CALIFORNIA COASTAL COMMISSION

W18a

Subject: UCSC Marine Science Campus Coastal Long Range Development Plan (CLRDP) Notice of Impending Development 1 (Overlook B). Coastal Commission consideration of UCSC's notice regarding their intent to redevelop the Overlook B area, including development of a new outdoor research yard and Overlook B public access improvements, pursuant to the certified CLRDP.

PROPOSED DEVELOPMENT

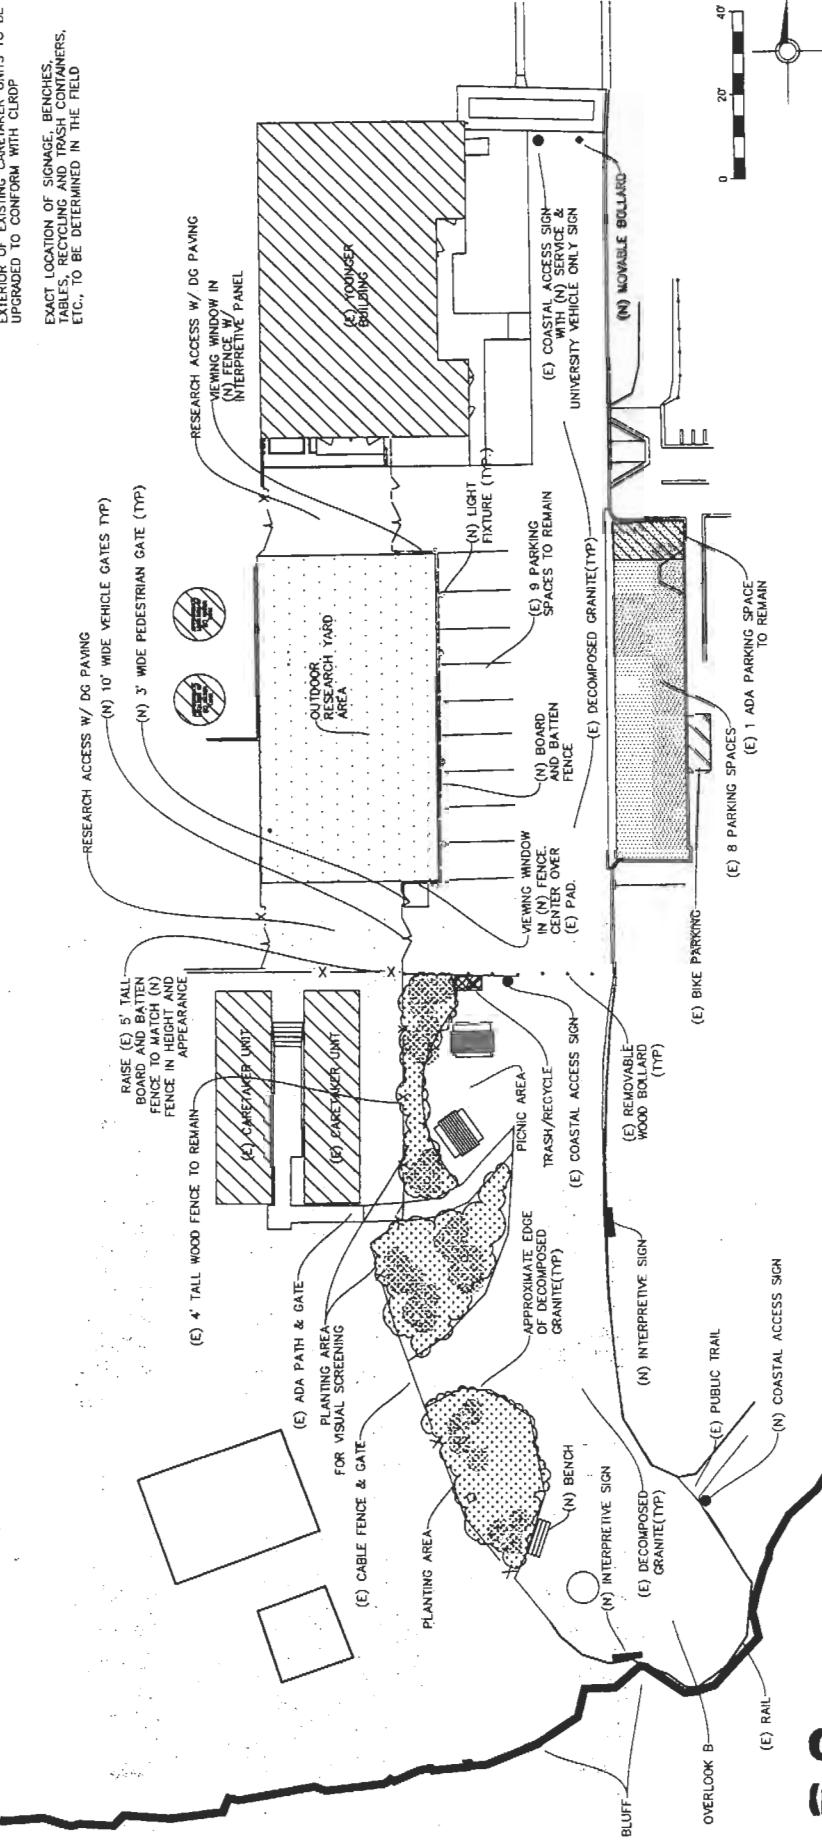
enhance the public's experience of the Overlook B area. In the past, however, the location, size, and text of public access signage in this area have sometimes been insufficient to adequately inform the public of its right to access this area. As clearly articulated by the CLRDP, signage for public recreational access use at the Campus is critical to the success of such access, including because, as is the case here, such access is through and adjacent to existing working laboratory operations that are clearly off limits. That "off-limits" perception can extend to public accessways without clear information to the contrary. In this case, UCSC has not provided any detail regarding the public access signs that would be installed. Thus, Special Condition 2 is needed to assure that the new public access signage, including the interpretive signage adjacent to the outdoor research area, is conspicuous and appropriately located to provide clear guidance to the public as to existing public access resources, without impacting coastal views or the character of the Overlook B area.

The proposed development also calls for using the two existing parking areas⁴ east and west of the pedestrian accessway for University and/or service vehicles only. Moveable bollards with signage at the northern entry to the Overlook B area will identify the coastal access pathway, as well as restrict vehicular access to this area to University and/or service vehicles only (see Exhibit C for proposed development plans).

The concern regarding parking in this area is that it could have a detrimental impact on the public access amenities of Overlook B due to ongoing traffic in and out of the Overlook B area, i.e. a constant stream of vehicles in and out of the Overlook B area may diminish the primary public access intent of this area. Section 7.2.4 of the CLRDP, however, allows for vehicular access to this area and associated parking as long as this vehicular access/parking is limited to University-owned and/or service vehicles. In addition, Implementation Measure 5.5.6 requires that the parking in this area be further restricted to University-owned vehicles that are typically parked without movement for longer periods of time and that are not typically moved in and out of parking spaces multiple times during the day, as well as to service vehicles that cannot feasibly park elsewhere. Such limitations should help to ensure that this area is seen primarily as a pedestrian public access area. The proposed project description, however, does not specify the manner in which parking in this area will be controlled and limited primarily to University-owned vehicles that are not moved in and out of these parking spaces multiple times per day. Thus, Special Condition 3 requires submission of a parking plan that will limit parking to University-owned and/or service vehicles only, and will further detail how the University will control the daily movements of these vehicles. As conditioned to provide a parking plan, and a public access signage plan as discussed above, the proposed development is consistent with the public access requirements of the CLRDP.

- 2. Public Access Sign Plans.** PRIOR TO COMMENCEMENT OF CONSTRUCTION, UCSC shall submit two copies of Public Access Sign Plans to the Executive Director for review and approval. The Sign Plans shall identify the materials, design, text, size, and precise location of each public access sign, where each such sign shall be sited designed to provide clear public access information without impacting public views and site character.

- 3. Parking Plans.** PRIOR TO COMMENCEMENT OF CONSTRUCTION, UCSC shall submit two copies of Parking Plans to the Executive Director for review and approval. The Parking Plans shall clearly identify all measures to be taken to ensure that parking in the area extending seaward from the northern edge of the Younger Building and the northern edge of the whale skeleton (at the northwest corner of the Seymour Marine Discovery Center): (a) is clearly limited to University-owned vehicles that are typically parked without movement for longer periods of time and that are not typically moved in and out of parking spaces multiple times during the course of a day, and service vehicles that cannot feasibly park elsewhere and still provide the required service; (b) is designed to limit vehicular ingress and egress as much as possible to ensure that public access in and through this area is protected and enhanced; and (c) is prohibited for any other type of parking (including but not limited to parking for University staff and visitors).
